Colorado Department of Health  
Hazardous Materials & Waste Management Division  
Comments  
on  
FINAL  
RFI/RI WORK PLAN  
FOR  
OU-12  
(400/800 Area)  
ROCKY FLATS PLANT  
OCTOBER, 1992

FIGURE 6-11  
FIELD SAMPLING PLAN FOR  
IHSS 147.2-BUILDING 881  
CONVERSION ACTIVITY

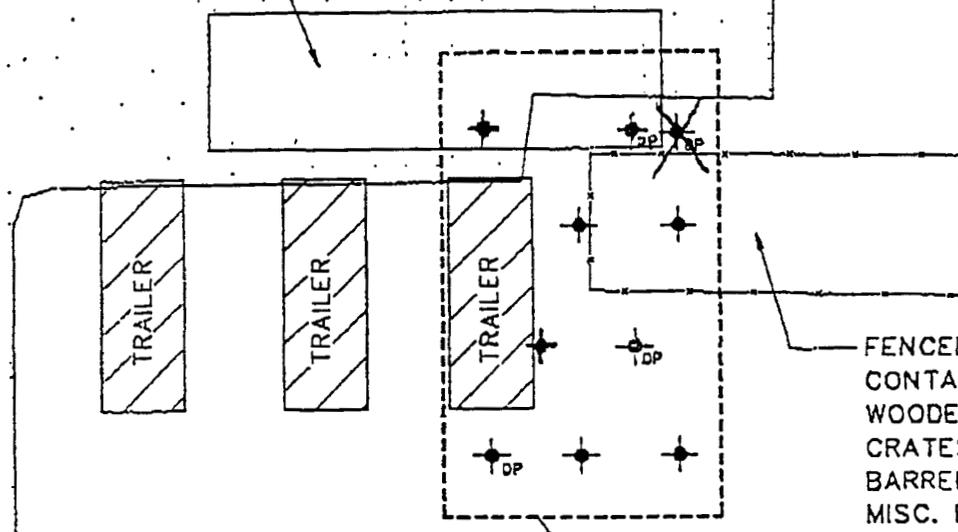
Section 6.3.10: The statement is made in the first paragraph that the "steel boxes containing depleted uranium will be removed prior to conducting any sampling at this IHSS." Consequently, the FSP as shown on Figure 6-11 must be altered and expanded. A revised Figure 6-11 is attached which shows the addition of two sites and the relocation of a third site.
